STAFF REPORT

SUBJECT: Windrow Neighborhood
[H-2023-0031](#)

LOCATION: Located at the NEC of S. Linder Road and W. Amity Road in the SW ¼ of Section 25, Township 3N, Range 1W (Parcels #S1225347078, #S1225325700, #S1225336520, #S1225336505).

G. Block Length Exhibit

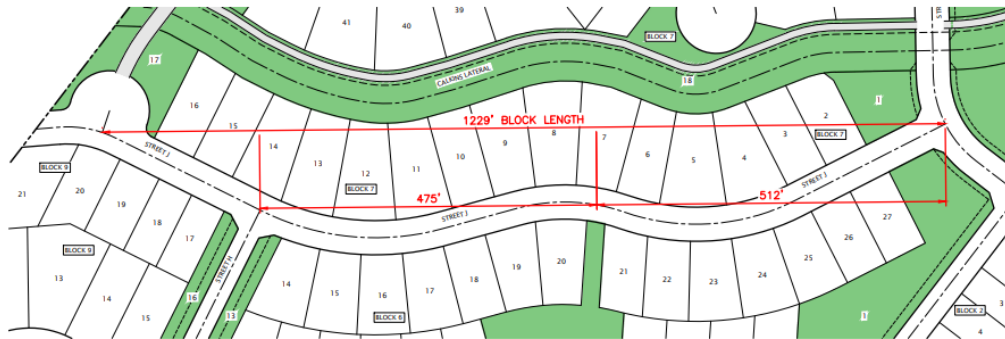
Block length is required to comply with the standards listed in UDC 11-6C-3F. Block faces should not exceed 750' in length without an intersecting street or alley unless a pedestrian connection is provided, then the block face may be extended up to 1,000' in length. In accordance with UDC 11-6C-3F.4, a block face should not exceed 1,200 feet, unless a waiver is granted by the City Council. In certain cases, as specified in section (F)(3) of this regulation, traffic calming measures may be necessary for blocks that surpass 1,000 feet in length. *Staff finds that Street A, Street B, Street C, and Street M each include a pedestrian connection that meets the conditions outlined in UDC 11-6C-3F as stated above. Staff has determined that Street L should incorporate a pedestrian connection located within Block 11 that connects to the east to break up the block length. The Applicant has initially proposed a block length of 1,229 feet for Street "J" in Section VIII.H; however, upon verifying the measurement, Staff found that Street "J" actually exceeds a length of 1,800 feet. The Applicant is seeking a Council Waiver for the block length. However, Staff believes in order for the Council to grant the waiver, the Applicant should extend a public street across the northern edge of the Calkins Lateral in the location where the emergency access is proposed. This topic was discussed during the pre-application meeting. The applicant has indicated that the irrigation district wants to limit the number of crossings over the lateral however, staff doesn't have any written documentation of such a request. Staff recommends that the applicant provide written documentation from the irrigation provider stating that another public street connection is not desired prior to the City Council hearing. Moreover, to help reduce traffic speeds, the design of Street "J" incorporates curves, however, the applicant should still incorporate traffic calming measures as required by ACHD and UDC11-6C-3F. Further, Staff recommends that the Applicant incorporate an additional pedestrian connection and pedestrian bridge over the Calkins Lateral from the north side of this road through Lot 46 or Lot 47, Block 7 to align with the cul-de-sac. Incorporating an additional pedestrian bridge in the center of the development enhances accessibility to the open space and amenities within the area. If the applicant doesn't want to extend the road and install the additional open space and pedestrian bridge as recommended, the block length for street "J" should not exceed 750 feet as required by the UDC.*

- f. Other Staff commenting on application: None
- 2. Key issue(s) of public testimony:
 - a. None
- 3. Key issue(s) of discussion by Commission:
 - a. Concerns with the Block length of Street “J” and how to mitigate the traffic flow.
- 4. Commission change(s) to Staff recommendation:
 - a. None
- 5. Outstanding issue(s) for City Council:
 - a. None

- d. Consistent with ACHD conditions of approval and UDC 11-6C-3F, provide traffic calming measures along Street A, Street B, Street C, Street J, Street L, Street M, and Street O to help mitigate its long and straight design or revise the plat to redesign the roadways. The Applicant is seeking a Council Waiver for Street J due its block length exceeding 750-feet.

Exhibit J – Parking Plan

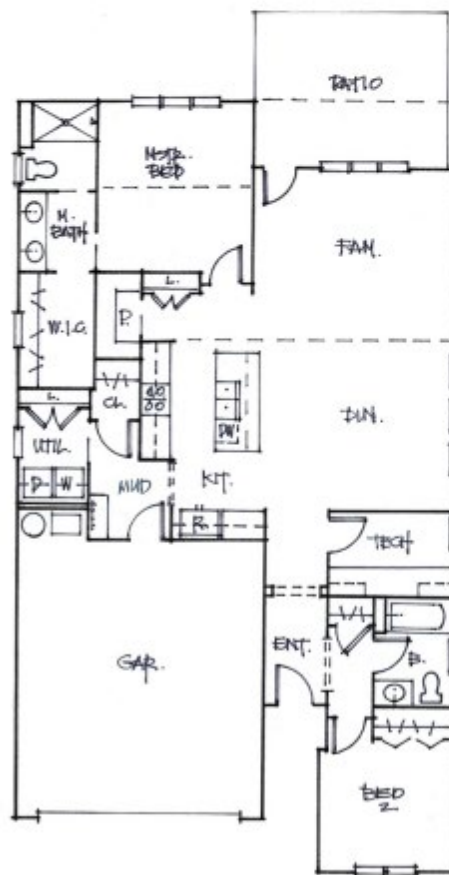
According to the submitted elevations, each home is proposed with a two-car garage or a three-car garage which presumes a 3 to 5-bedroom home and would require a minimum 20-foot to 3-foot wide driveway for each building lot. In addition, as discussed above, some of the streets within this development are proposed as 27-foot wide street sections which only allow parking on one side of the street instead of both sides as allowed on the standard 33-foot section. The Applicant has submitted a "Parking Plan" that illustrates an additional 428 on-street parking

spaces (over 1.7 additional parking spaces per home) available for use by the residents (See Section VIII.I).
